STATE OF OHIO
DEPARTMENT OF TRANSPORTATION

HAM-75-14.61

1 2-19-2021 - Added Sheet 444A

TYPICAL SECTIONS - SHARON ROAD

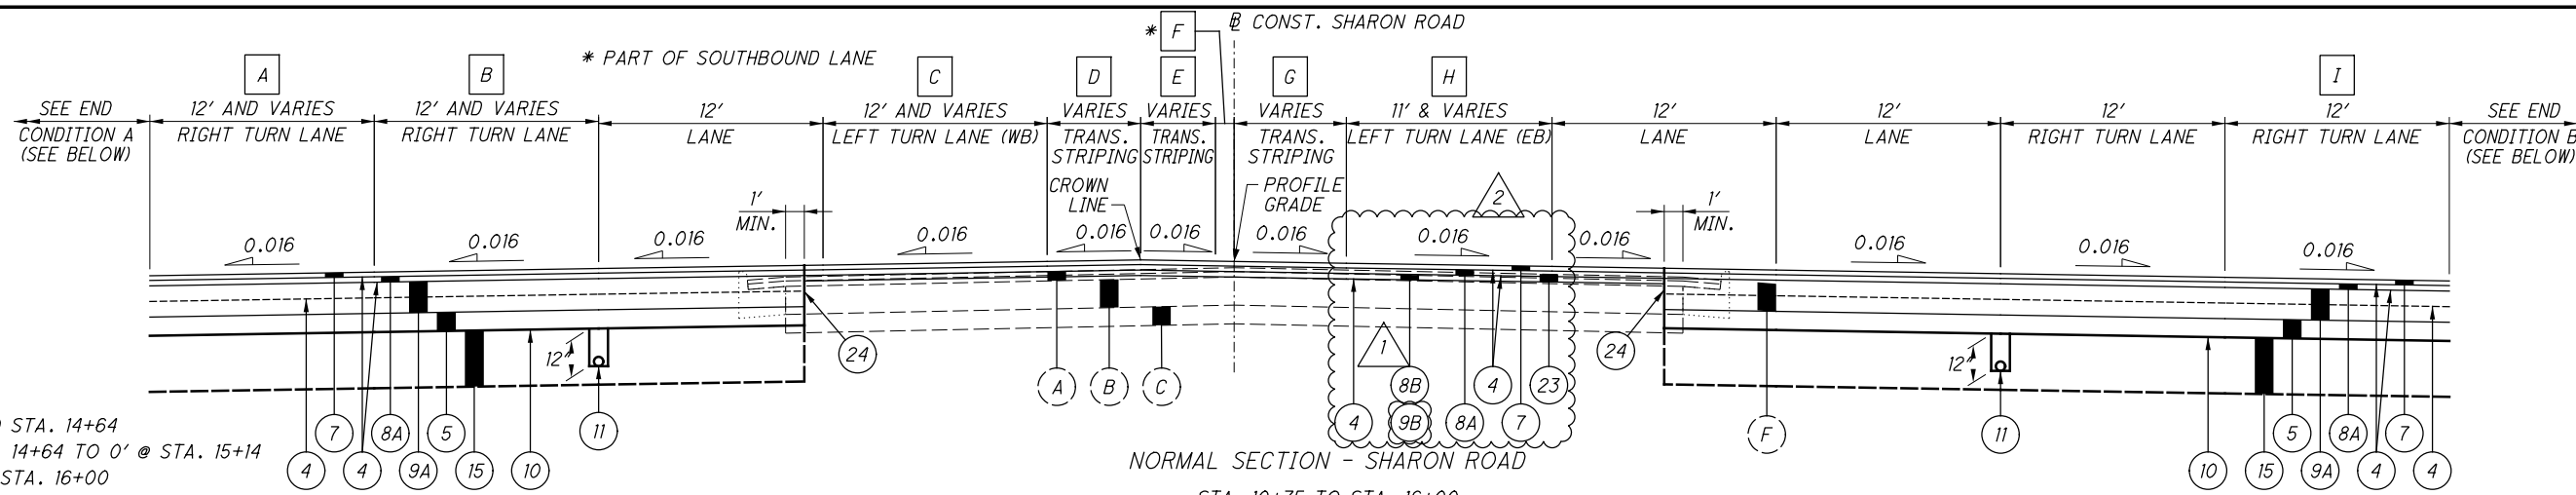
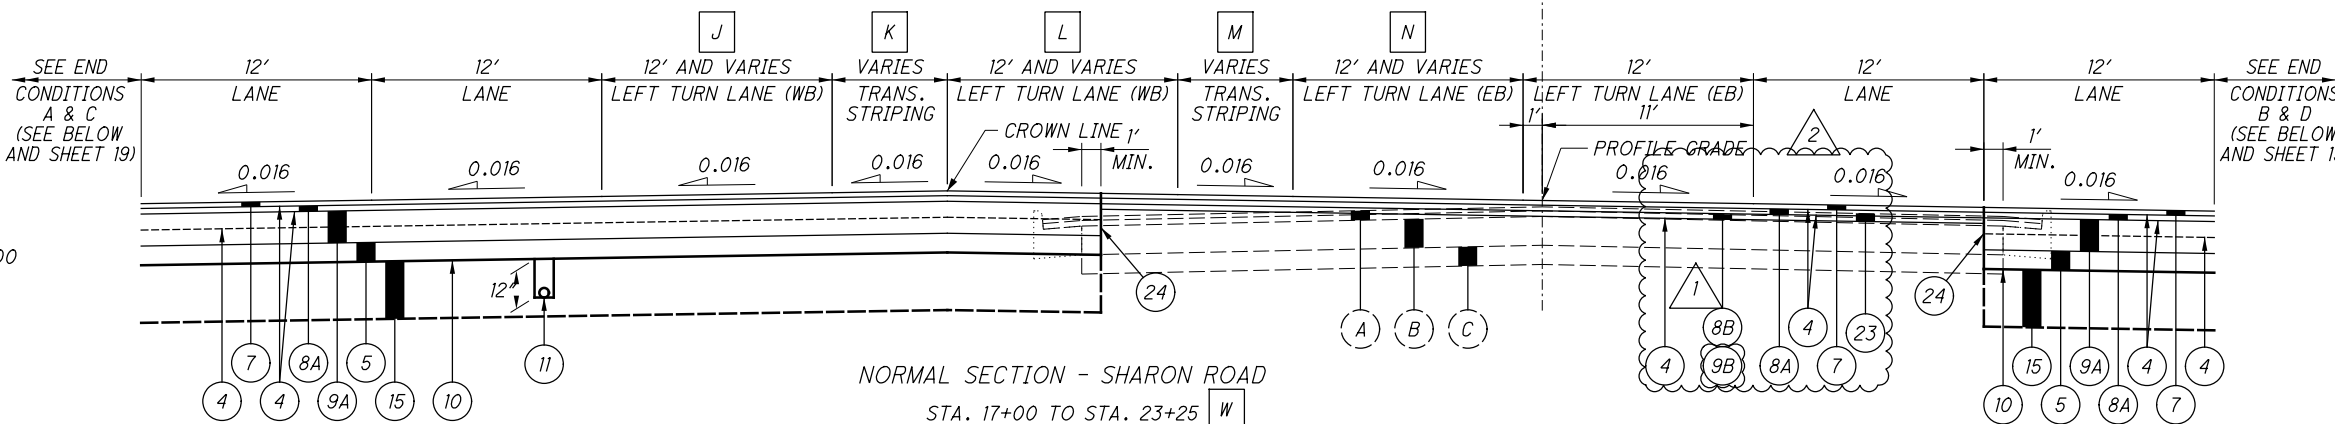
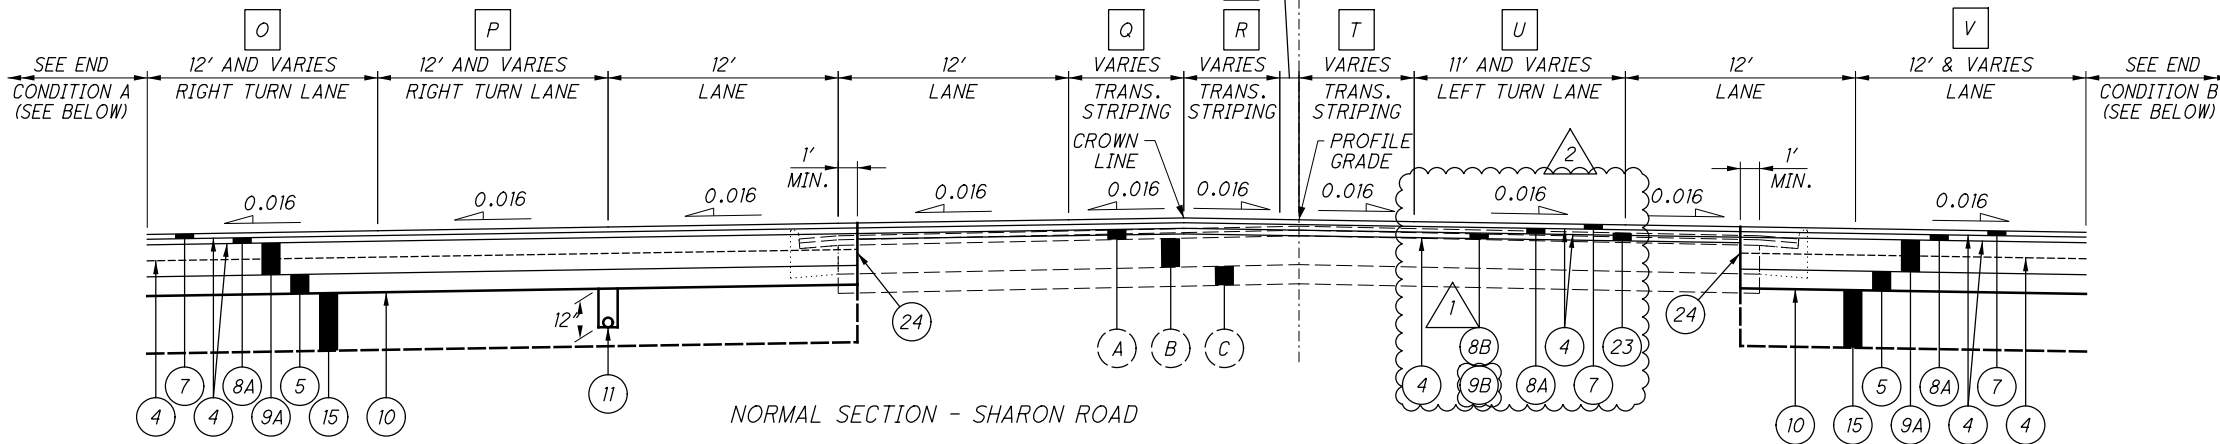
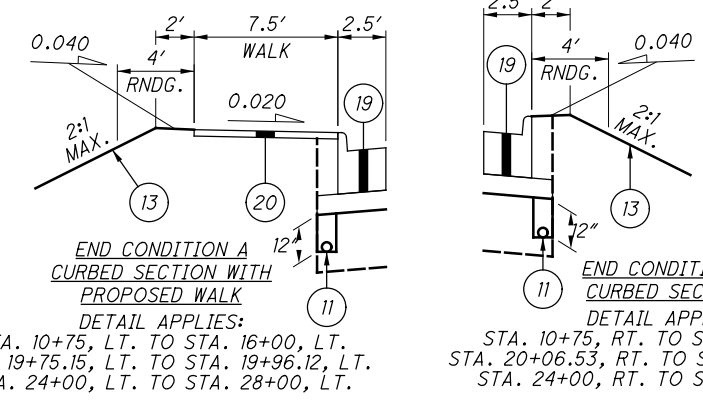
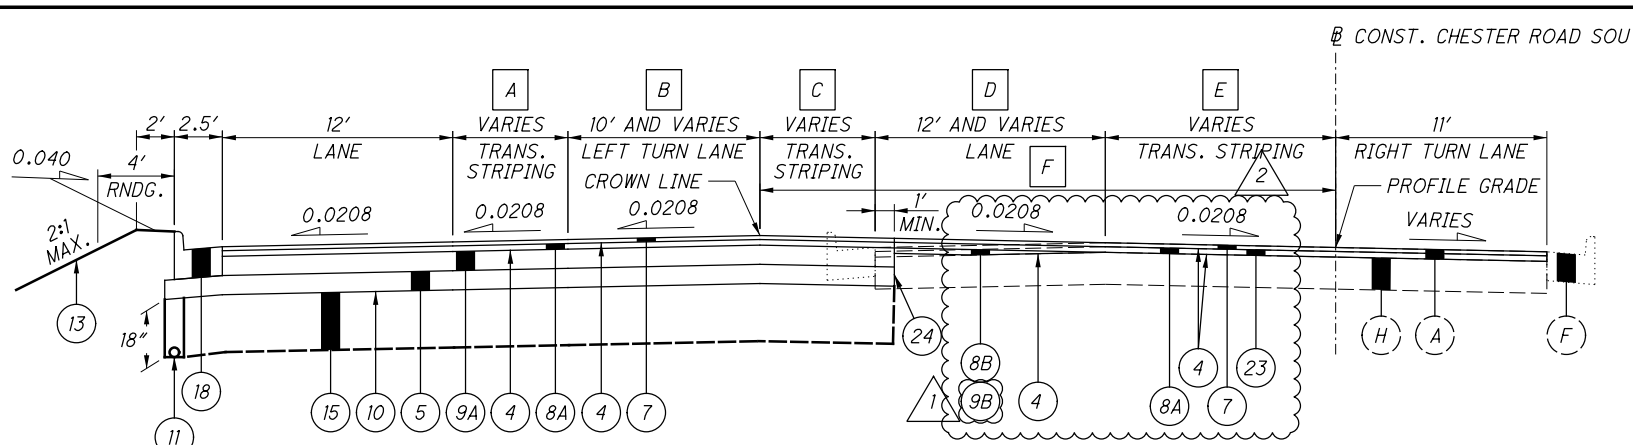
1 2-5-2021 - UPDATED TYPICAL SECTION BALLOON CALLOUT
 2 2-19-2021 - UPDATED TYPICAL SECTION BALLOON CALLOUTS FOR 8B AND 9B FOR CLARITY. ADDED SHEET REFERENCE TO "AS PER PLAN" NOTES AND UPDATED NOTES FOR CLARITY.

PARAPET PARTIAL ELEVATION
RIGHT PARAPET BACK FACE SHOWN

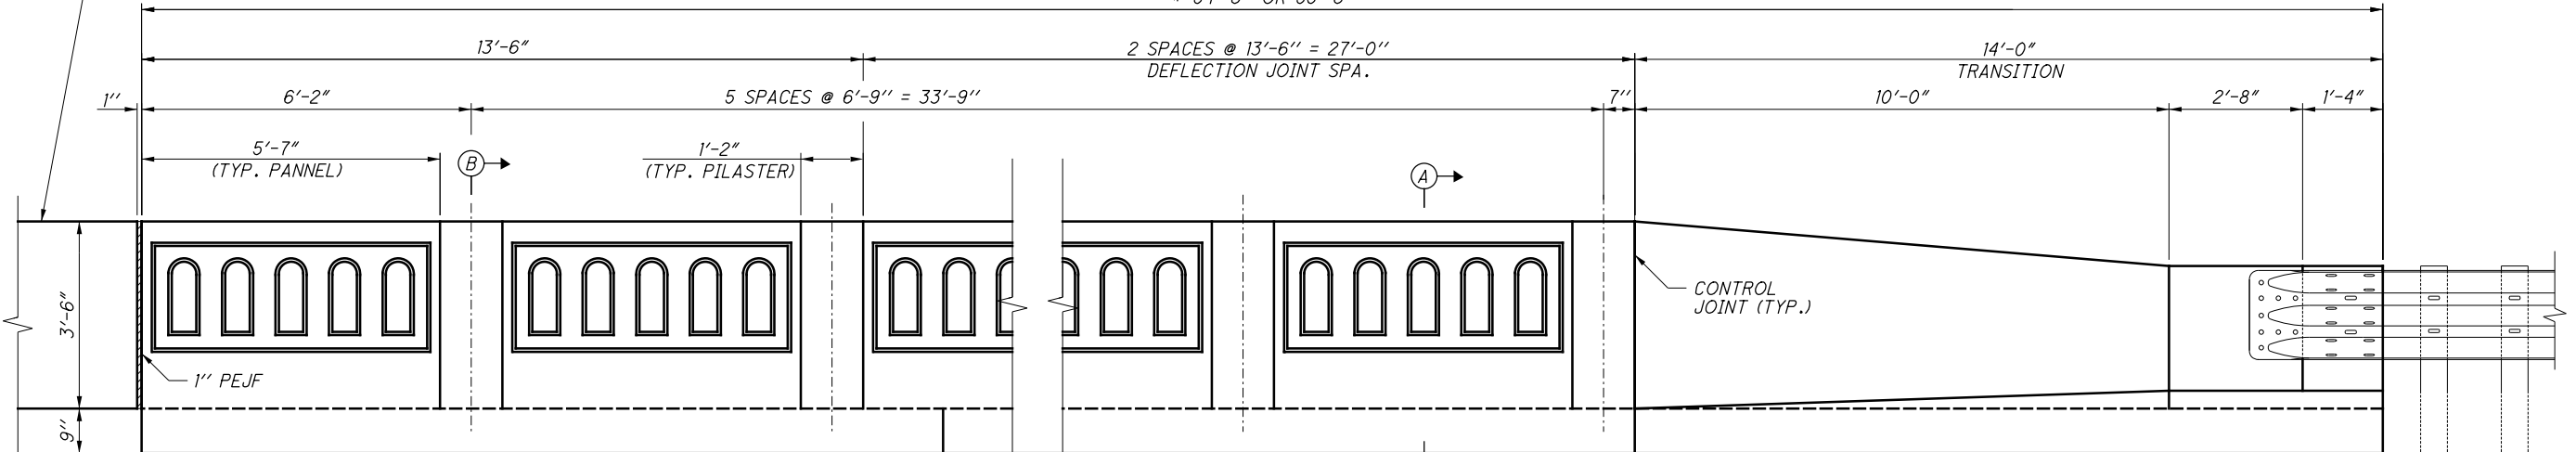
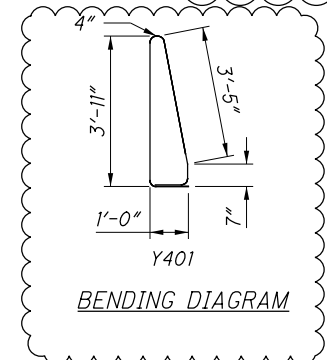
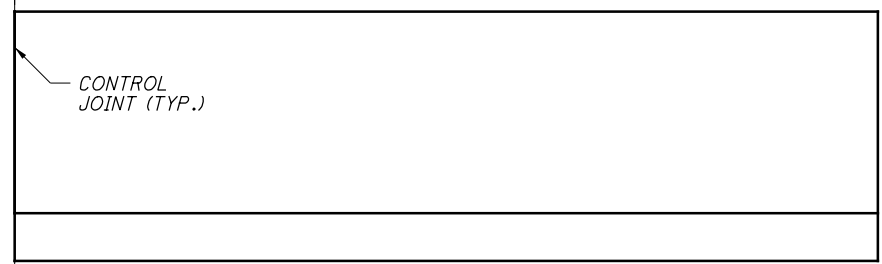
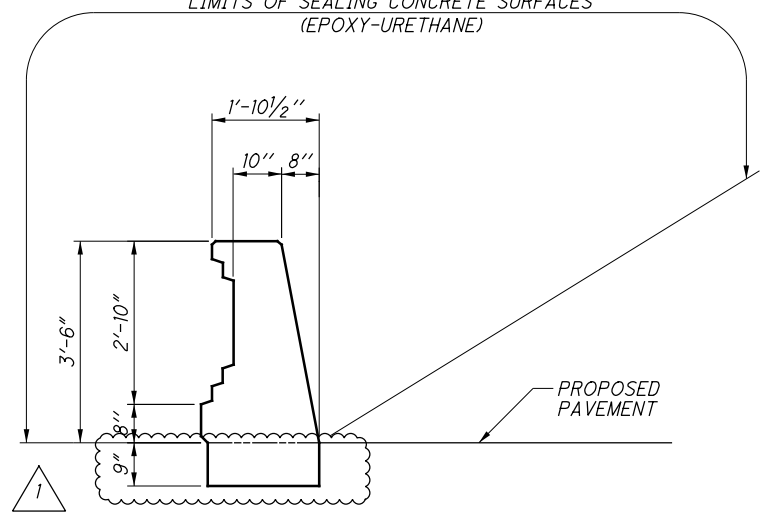
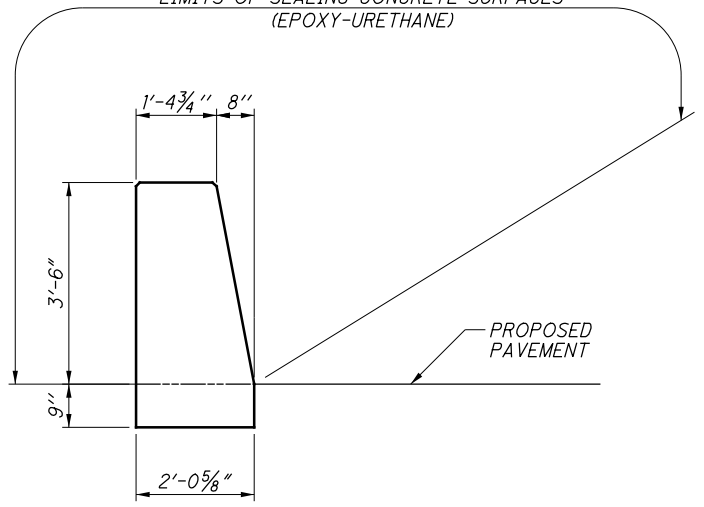
15'-0" ITEM 622 -
CONCRETE BARRIER, END ANCHORAGE REINFORCED TYPE D, AS PER PLAN
SEE ODOT SCD RM-4.5 FOR DETAILS.
REPLACE THE Y401 REBAR LISTED IN THE SCD RM-4.5 WITH Y401 SHOWN BELOW
SEE SHEET 22 FOR NOTES.

20'-0" ITEM 611 -
INLET NO. 3 FOR SINGLE SLOPE BARRIER, TYPE D, AS PER PLAN
SEE ODOT SCD I-2.3 FOR DETAILS.
REPLACE THE Y501 AND Y502 REBAR LISTED IN THE SCD I-2.3
WITH Y501 AND Y502 SHOWN ON SHEET 444A OF 708
SEE SHEET 23 FOR NOTES.

1 2-19-21 - MODIFIED BARRIER
DETAILS PROVIDED

SECTION C-C

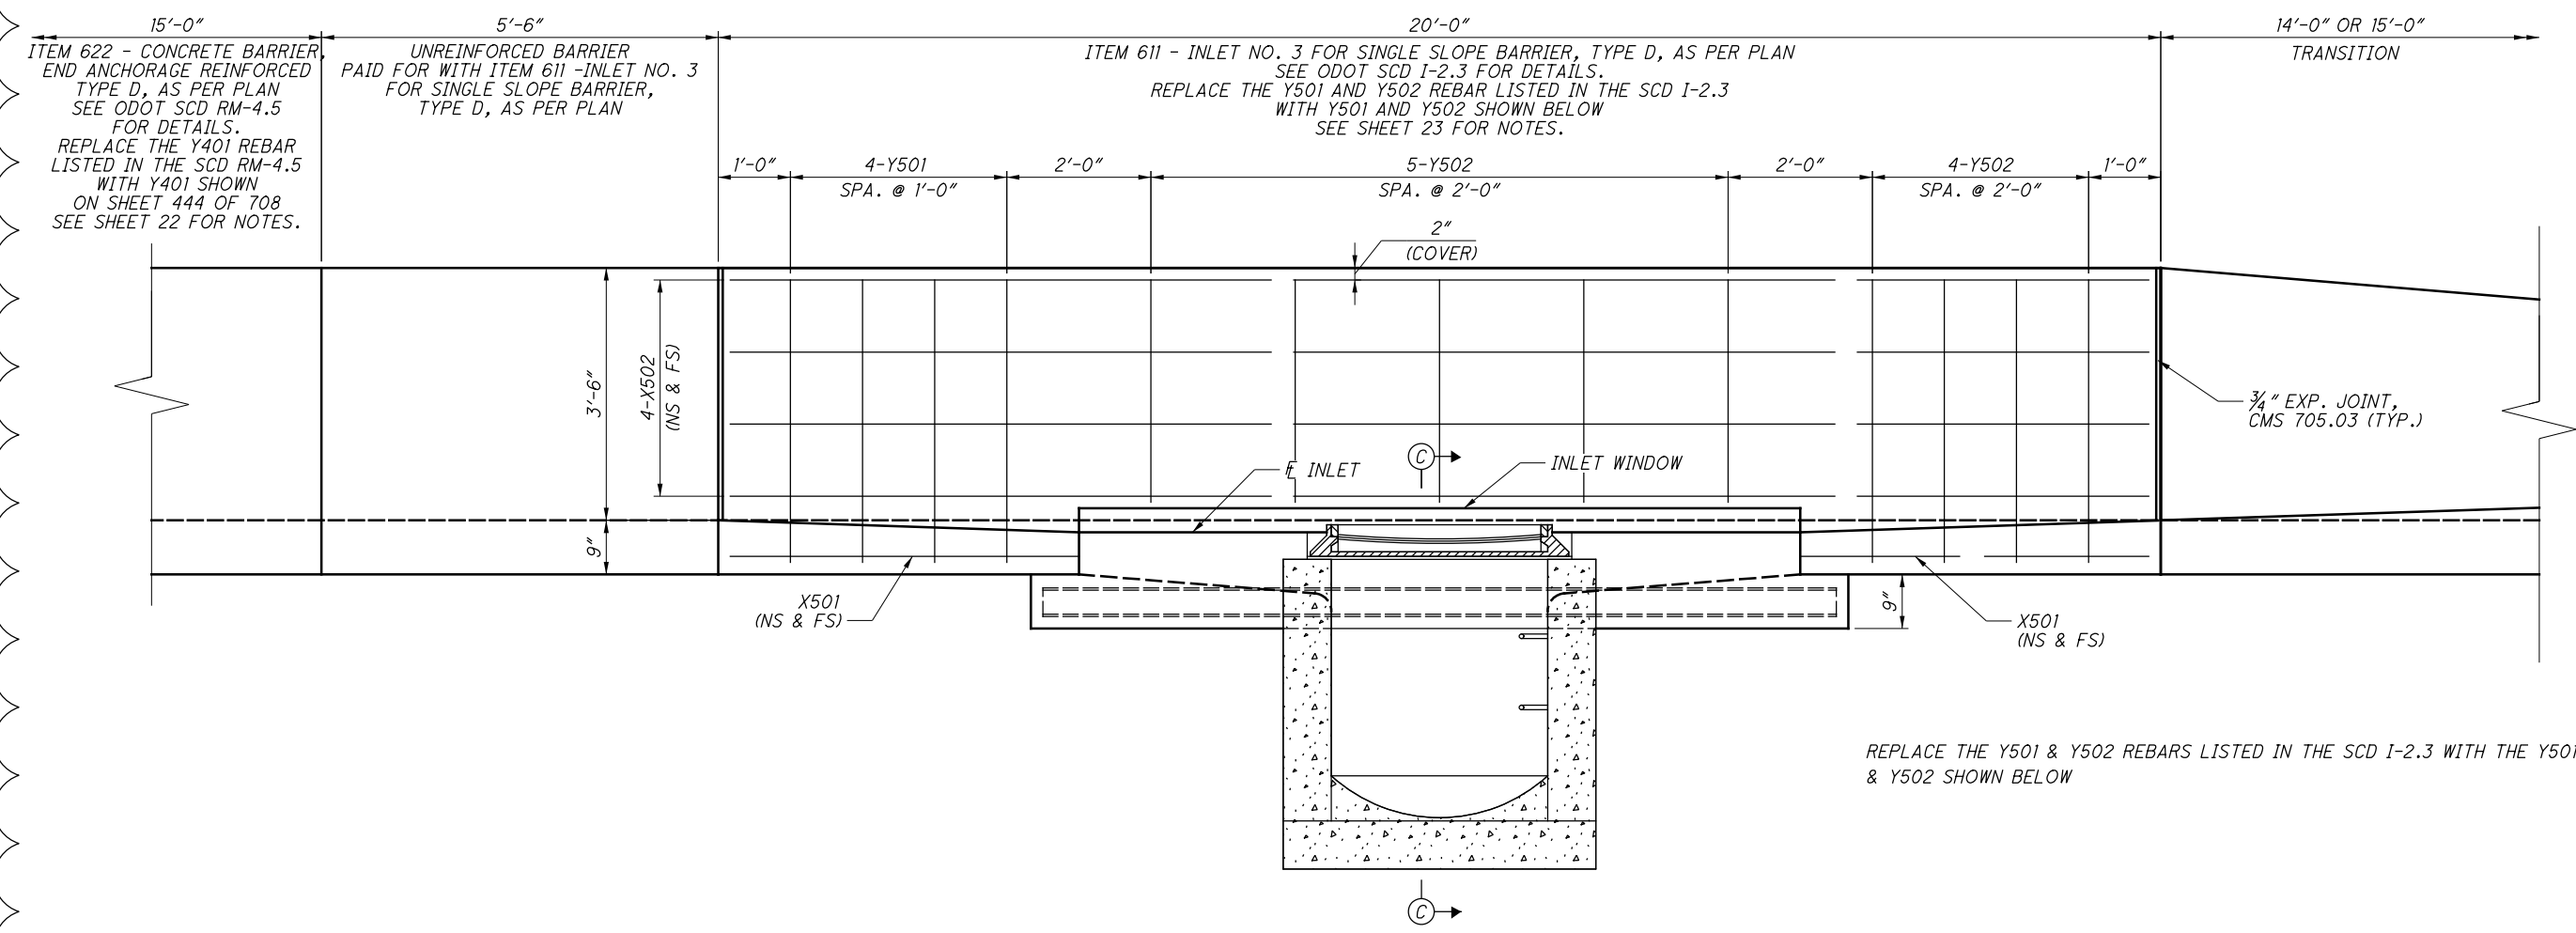
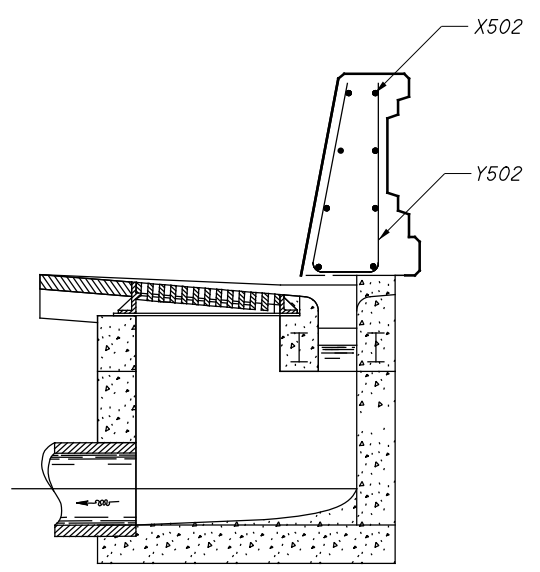
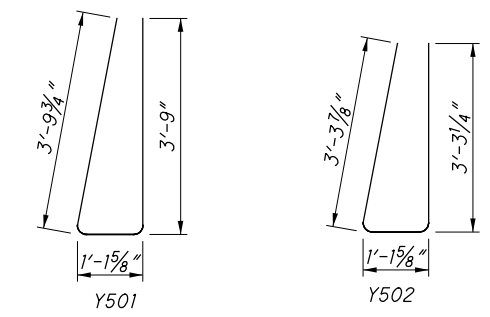
ITEM 622 - CONCRETE BARRIER END ANCHORAGE REINFORCED TYPE D, AS PER PLAN SEE ODOT SCD RM-4.5 FOR DETAILS. REPLACE THE Y401 REBAR LISTED IN THE SCD RM-4.5 WITH Y401 SHOWN ON SHEET 444 OF 708 SEE SHEET 22 FOR NOTES.

ITEM 611 - INLET NO. 3 FOR SINGLE SLOPE BARRIER, TYPE D, AS PER PLAN SEE ODOT SCD I-2.3 FOR DETAILS. REPLACE THE Y501 AND Y502 REBAR LISTED IN THE SCD I-2.3 WITH Y501 AND Y502 SHOWN BELOW SEE SHEET 23 FOR NOTES.

REPLACE THE Y501 & Y502 REBARS LISTED IN THE SCD I-2.3 WITH THE Y501 & Y502 SHOWN BELOW

1 2-19-21 - MODIFIED BARRIER DETAILS PROVIDED
